## Memorandum City of Lawrence Planning and Development Services

**RE:** Minor Subdivision, MS-15-00265, variance request from the 150' right-of-

way width requirements for Wakarusa Corporate Centre Addition No. 3, located in the 4900 block of Corporate Centre Dr. Submitted by Phillip DiVilbiss on behalf of Bristol Partners XII LLC and BCL Alameda LLC,

**Attachment A:** Minor Subdivision MS-15-00265 **Attachment B:** Approved Site Plan SP-03-20-2000

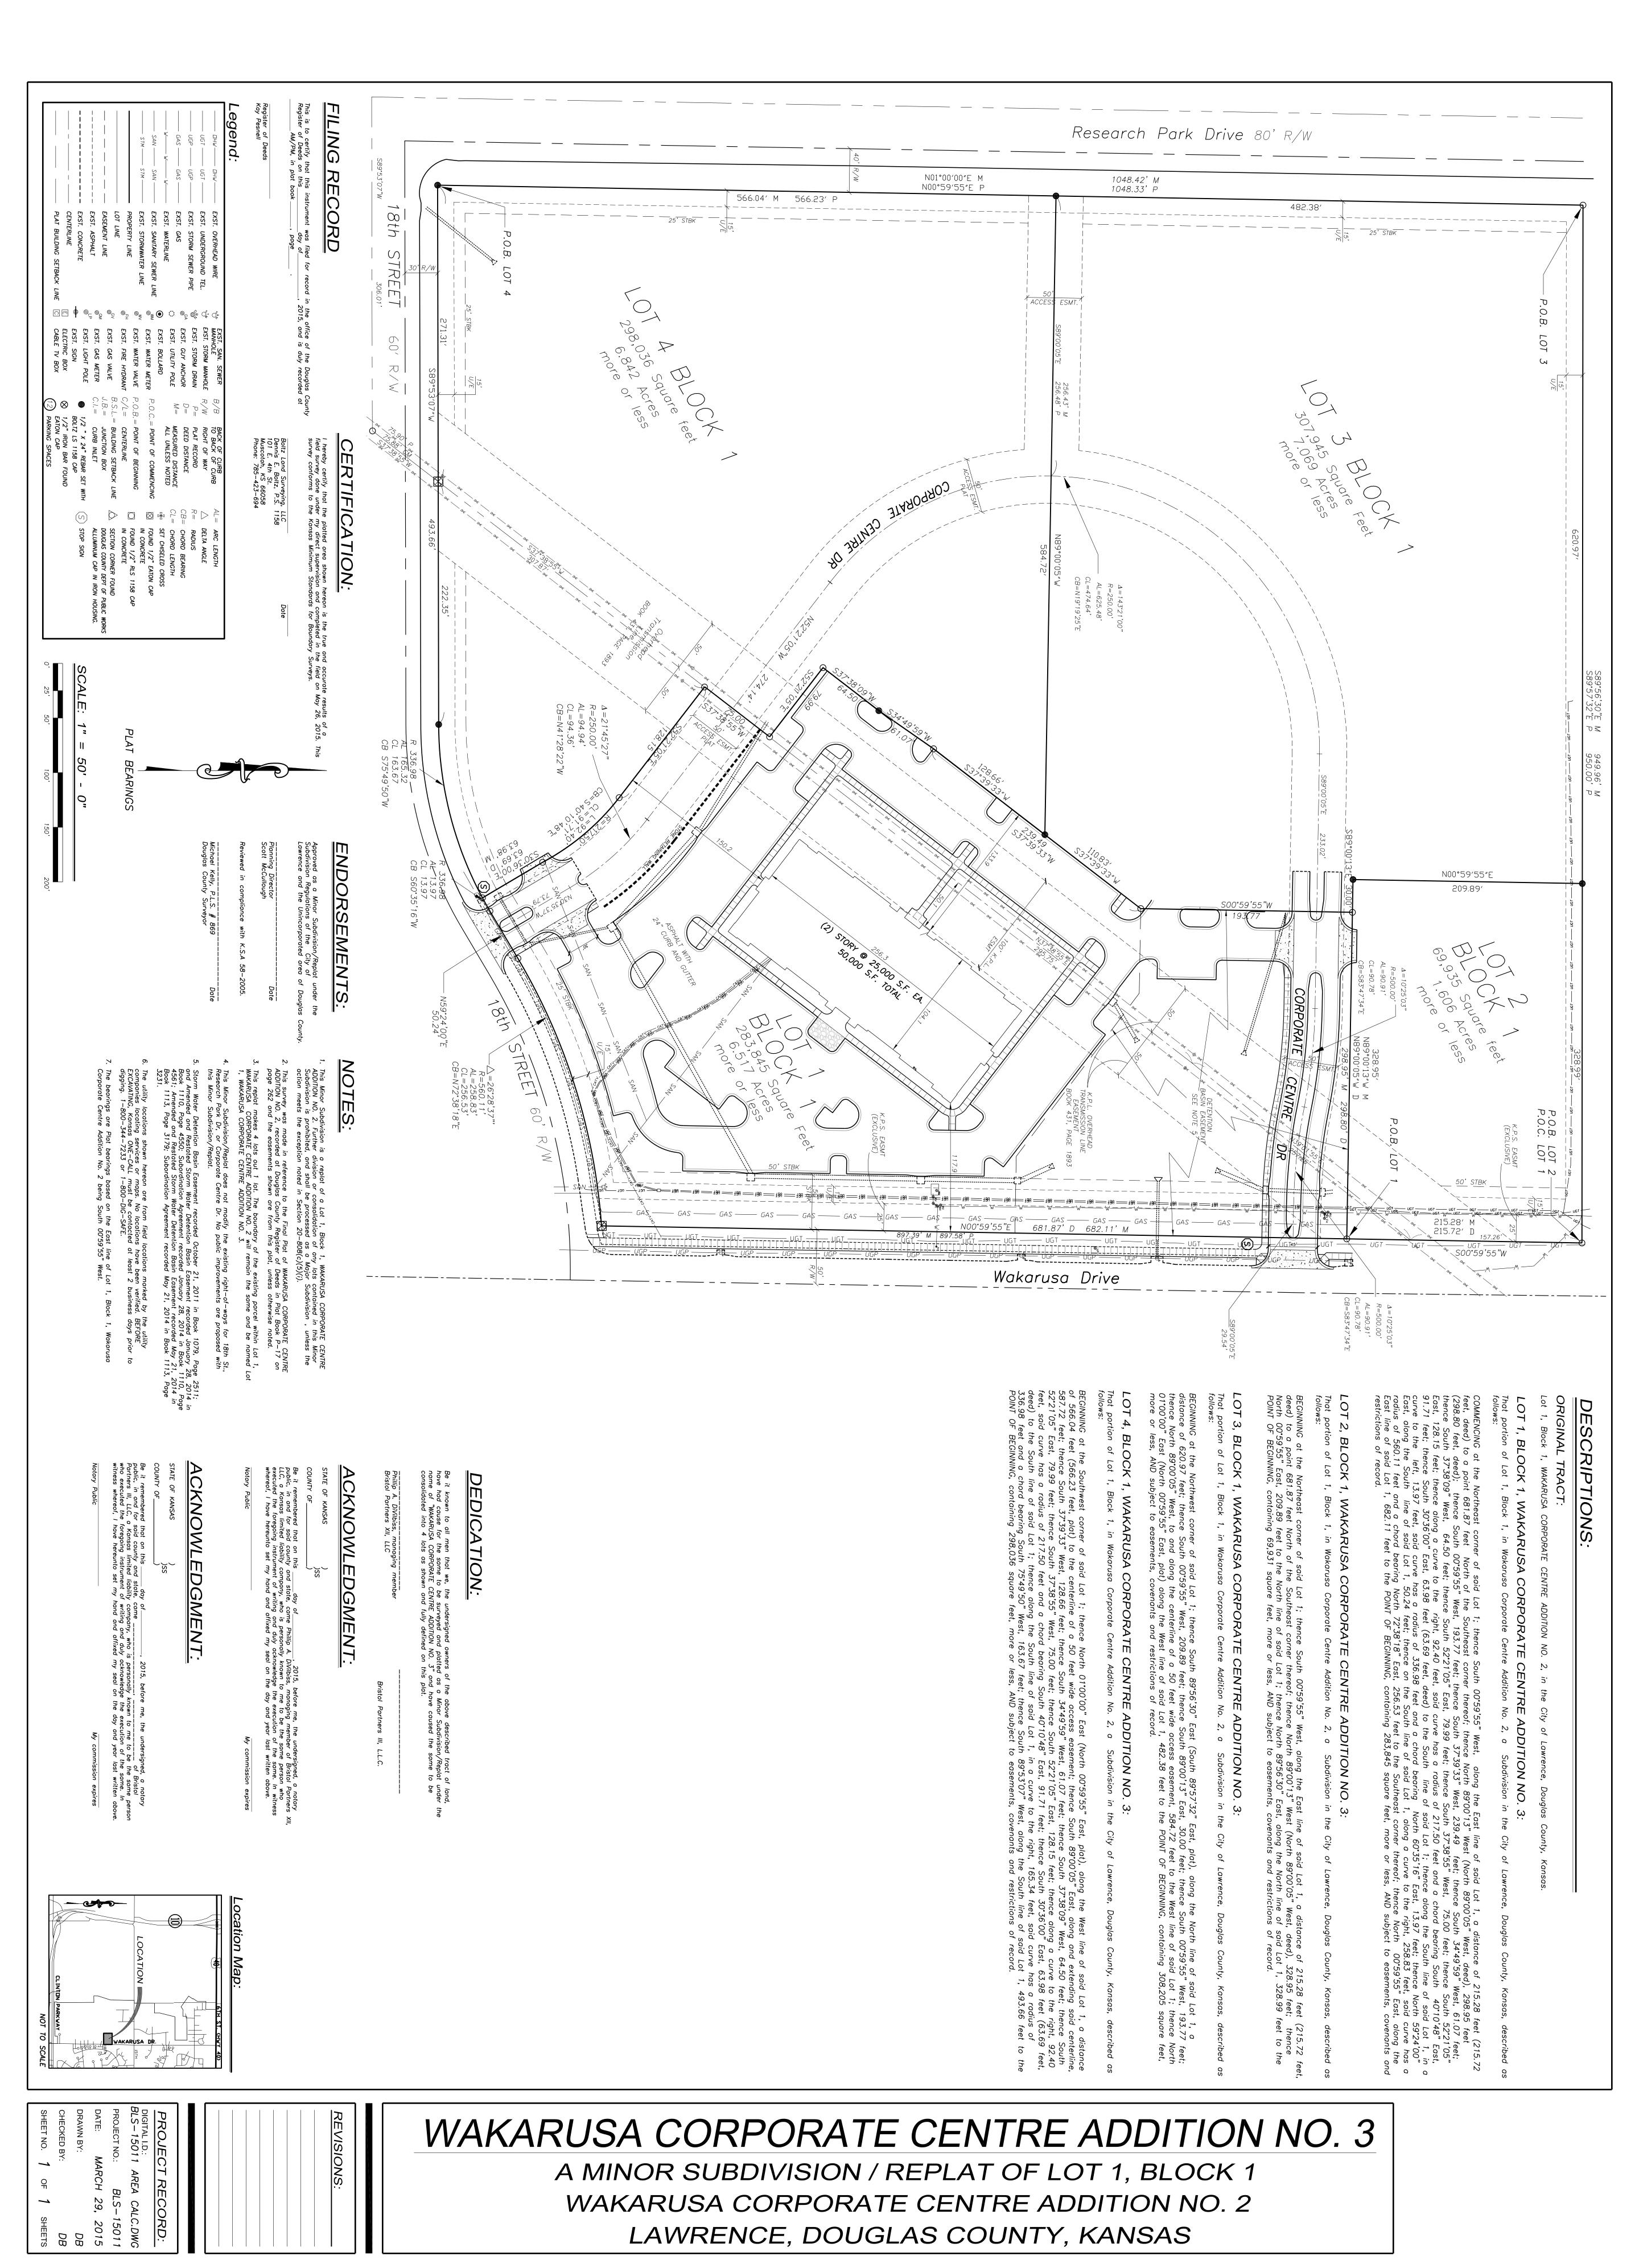
**VARIANCE:** Reduction in the width of right-of-way from 150' to 100' as required for a Principal Arterial Street (Wakarusa Drive) per Section 20-810 (e) (5).

The standard for the required right-of-way width changed in 2006 from 100′ to 150′. This area is developing with the 100′ right-of-way. There are a number of exclusive utility easements located parallel to Wakarusa Drive. The 150′ of required right-of-way is more applicable to new greenfield development rather than existing corridors.

The current width for Wakarusa Drive includes 100' of public right-of-way. Much of the corridor also includes parallel easements. Some of these easements are for the exclusive use for utilities such as electric or gas. The current subdivision regulations require principal arterial streets to include 150' of right-of-way. The current right-of-way is an existing condition of the corridor. New right-of-way was not proposed with the Minor Subdivision.

Approve the variance requested for a Minor Subdivision, MS-15-00265, variance request to reduce the right-of-way form Section 20-810(a)(5) for a principal arterial street from 150' to 100' per section 20-813(g) of the Land Development Code for property located in the 4900 block of Wakarusa Drive.
